Informal Document No. GRSP-38-14
(38th GRSP, 6th- 9th December 2005,
agenda item B.1.8.)

Japan's Comment on GRSP/2005/5 ECE-R.16

R.16 Test Results

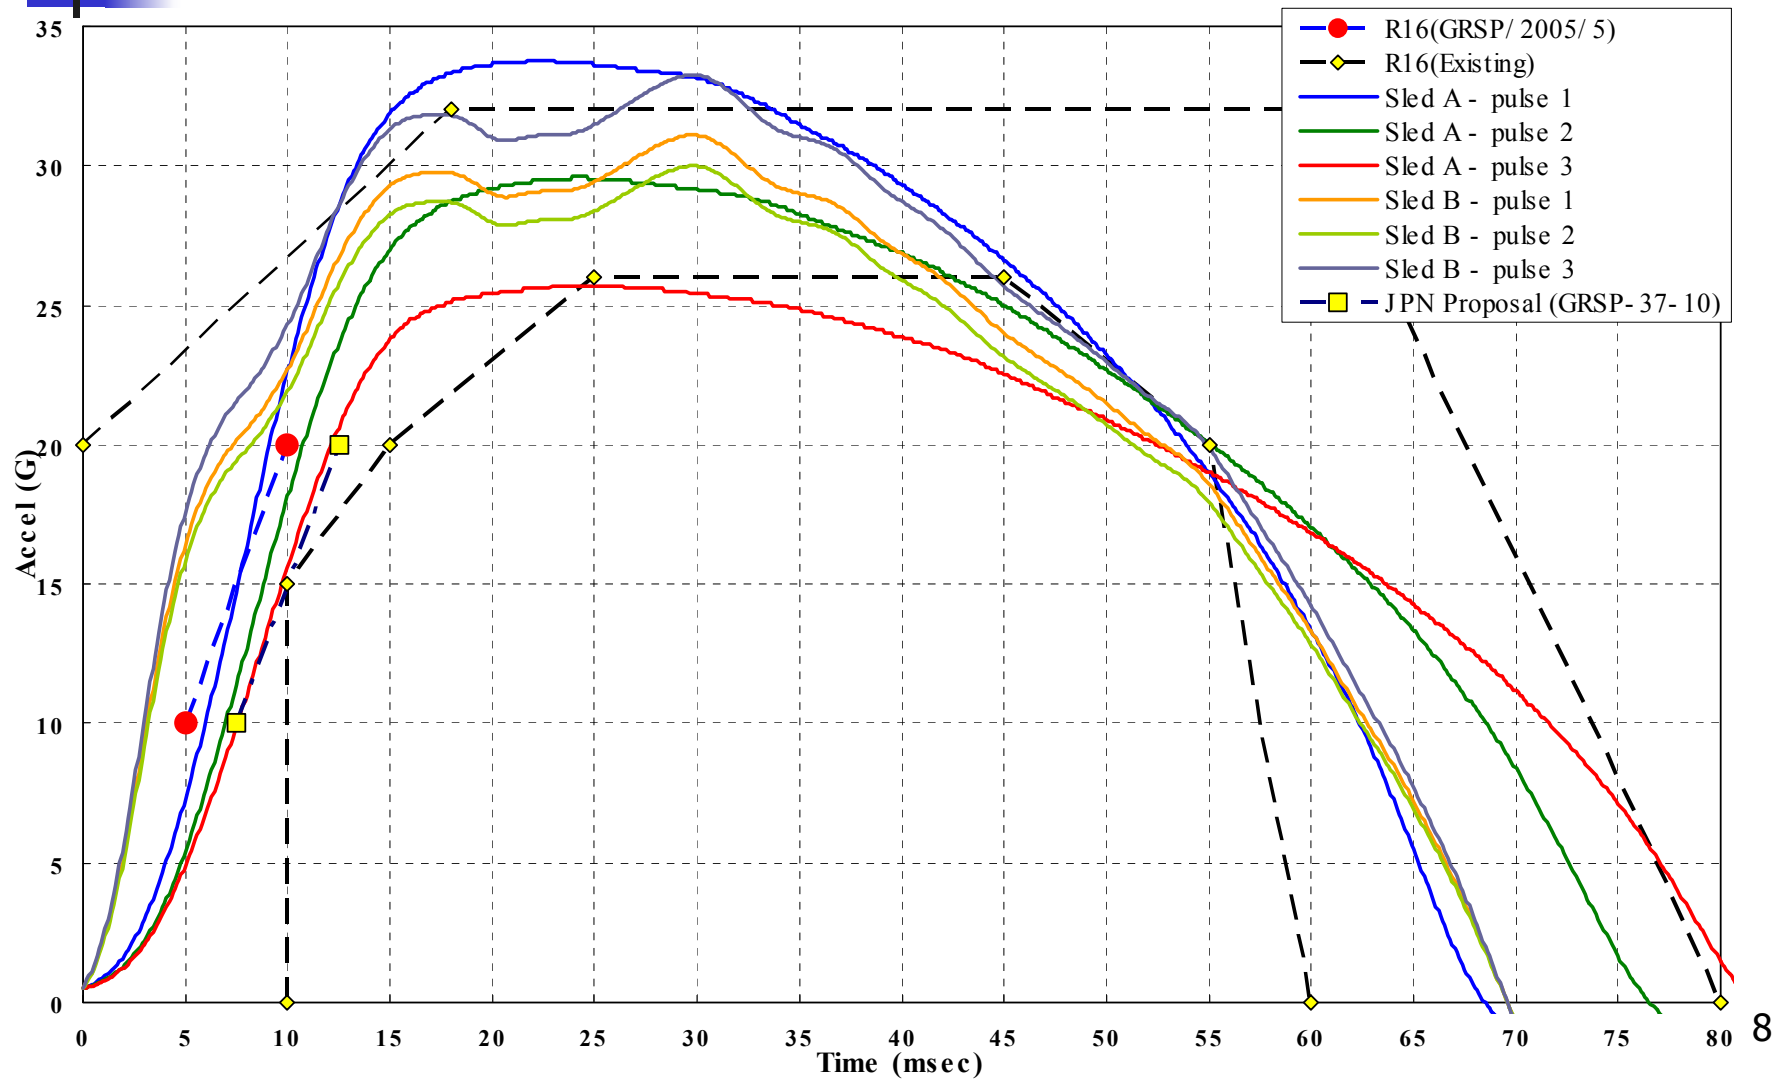
T/N	A	B	C	
	Conformity in Corridor	Sled Velocity	Curve condition	
		total □ □ km/h	at 5m s G	at 10m s G
R16 (GRSP/2005/5)	-	51+2/0	□ 10	□ 20
Sled A - pulse 1	Fail	54.85	7.31	22.7
Sled A - pulse 2	Fail	53.29	5.41	18.2
Sled A - pulse 3	Fail	49.97	4.93	15.6
Sled B - pulse 1	Fail	52.88	16.44	22.73
Sled B - pulse 2	Fail	51.00	15.86	21.93
Sled B - pulse 3	Fail	55.56	17.59	24.31

Sled A - pulse 4	Fail	54.16	4.87	18.46
Sled A - pulse 5	Fail	54.17	5.00	18.06
Sled B - pulse 4	Pass	52.76	9.85	21.02

No test devices in Japan meet all requirements 7

Sled Acceleration (GRSP-37-10)

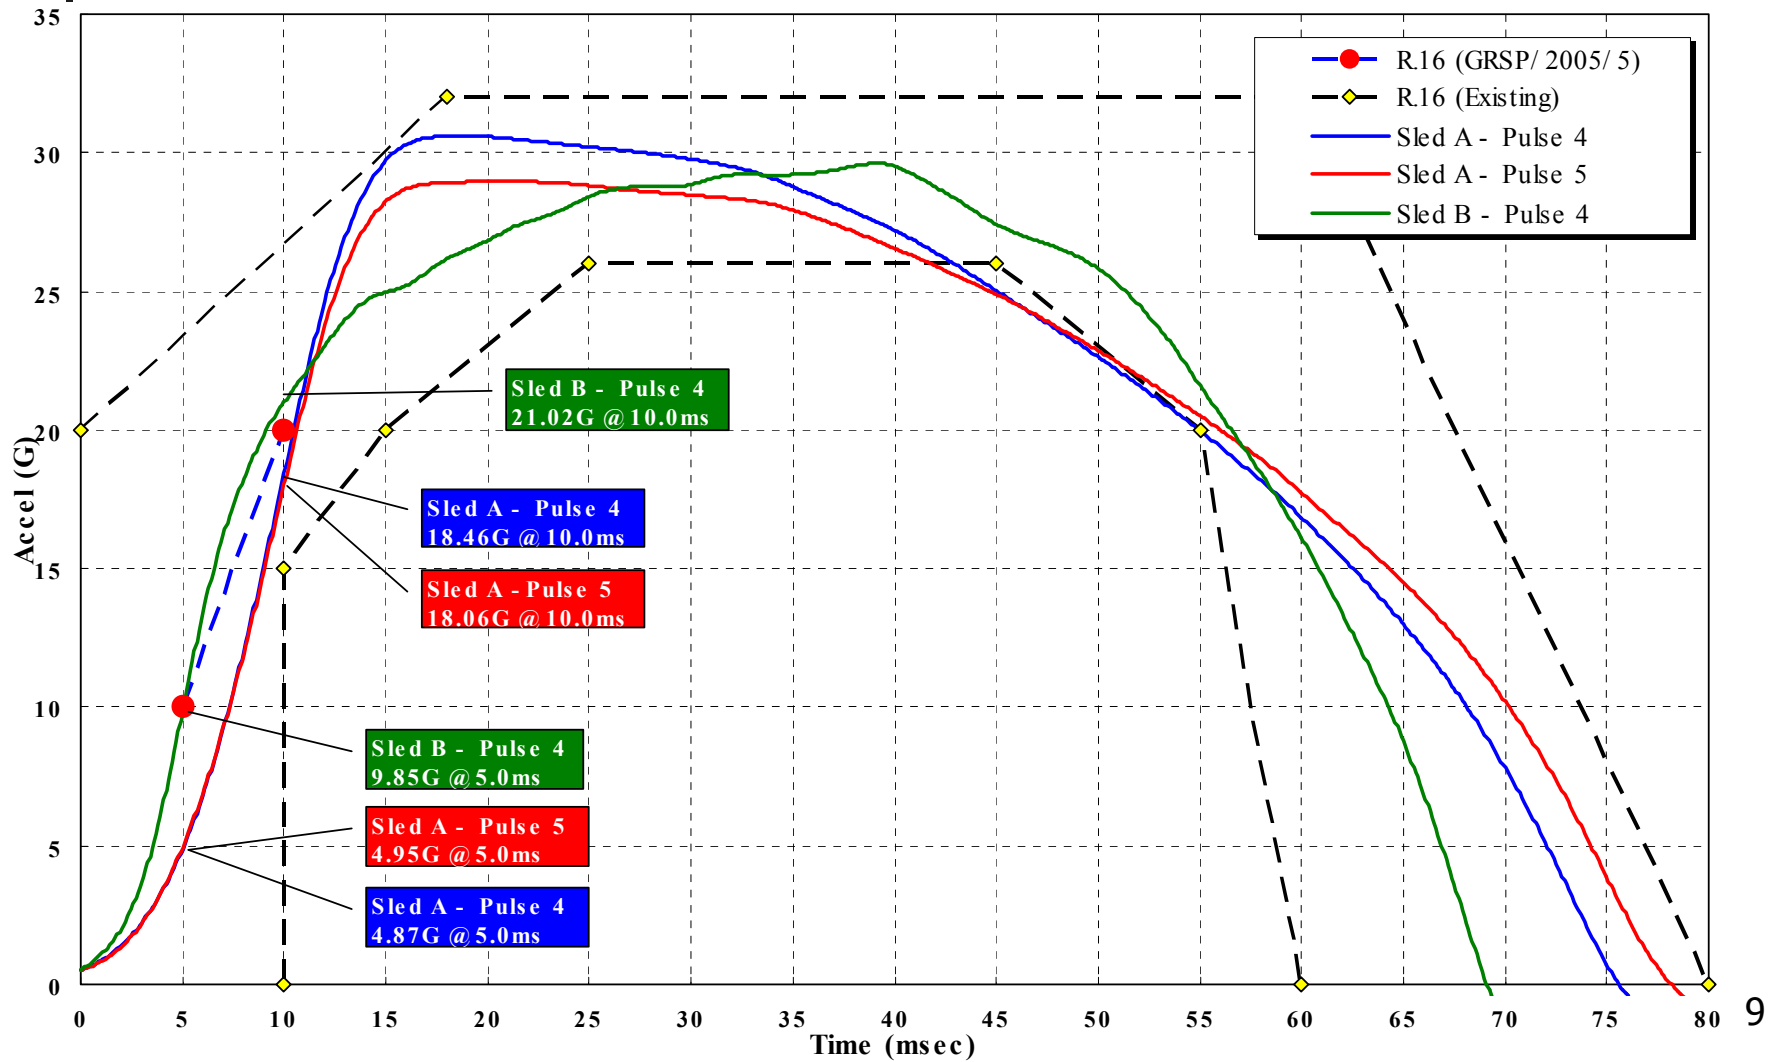
- The test was conducted using existing test facilities in Japan (HyGe). Unfortunately the test results did not fulfill all the proposed requirements.
- Especially as the 12inch HyGe Sled has heavy sled mass, the 5ms-10G and 10ms-20G requirements were very hard to be met for this size sled.

On the other hand, the specified ranges of accelerate corridor and speed will be hard to satisfy when trying to satisfy the initial slope of sled acceleration.

Sled Acceleration (New)

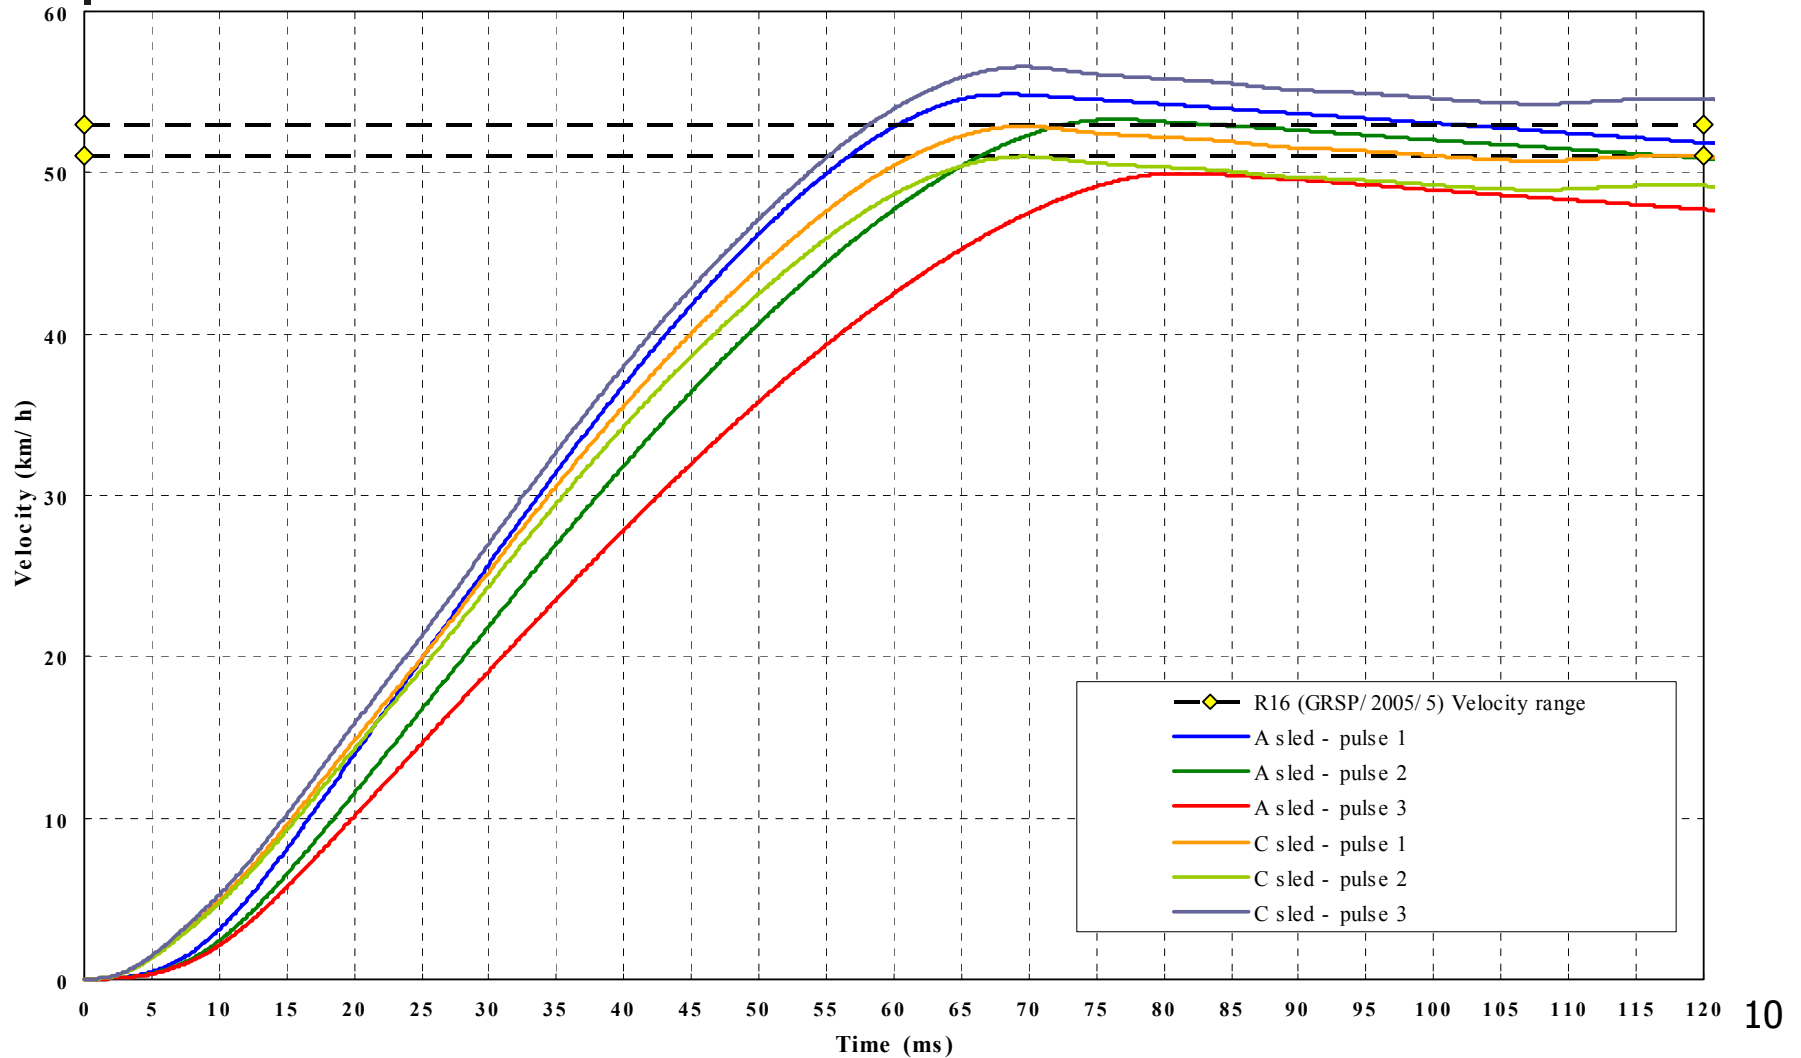
- Proposed conditions were achieved in one test with Sled B of smaller sled mass (9 inch, Sled mass = 700 kg), but could not be achieved in the other tests with Sled A of larger sled mass (12 inch, Sled mass = 1,100 kg).
- We would like to make tuned metering pin for current proposal and conduct verification test with 12 inch HyGe sled again, and then we will review the proposal by the 39th GRSP session.
